HORSHAM DISTRICT COUNCIL CONSULTATION

TO:	Horsham District Council – Planning Dept
LOCATION:	Mowbray Development Site Land North of Horsham West Sussex
DESCRIPTION:	Application for approval of Reserved Matters pursuant to Condition 5 of Outline Planning Permission reference DC/16/1677 for the Sports Hub including Pavilion and covered spectator stands, ancillary amenity buildings, access roads, landscaping, foot/cycle paths, car and cycle parking, and drainage including drainage basins, and associated infrastructure
REFERENCE:	DC/26/0012
RE-CONSULT:	1 st set of comments in black 2nd set of comments in blue
RECOMMENDATION:	Advice / More information Advice
SUMMARY OF COMMENTS & RECOMMENDATION: 2nd set of comments We have reviewed the response dated 20th March and it is regrettable that many of our concerns and recommendations have not been taken into consideration. These comments seek to secure a higher quality scheme that addresses the objectives of the development, protect its existing landscape features and secure its long-term use. We therefore expect the applicant to reconsider, highlighting that as they have recently removed proposed features such as wildflower planting, there

[DC/26/0012 left, DC/24/0917 right]

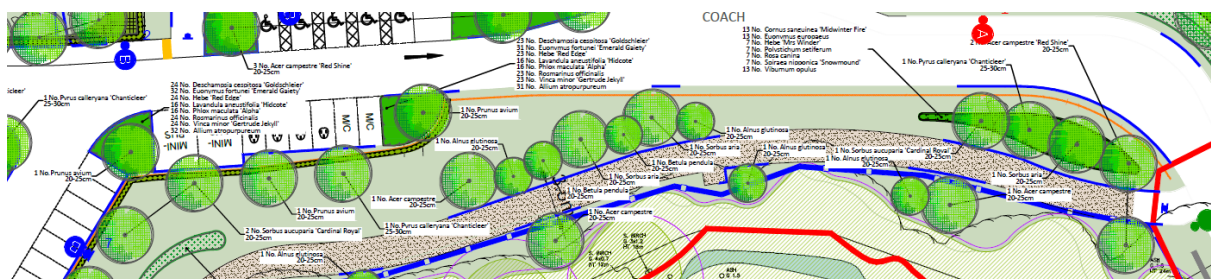
5. Areas of planting have been removed from within the bike track area in addition to 3no. trees. We request that these are reinstated.

We note response dated 20th March and respectfully request the evidence to demonstrate the health and safety concerns that could arise from the originally approved planting. In any case, we would be happy to consider an altered design as there is scope to position trees and planting further away from the track layout, however we are not supportive of its entire removal.
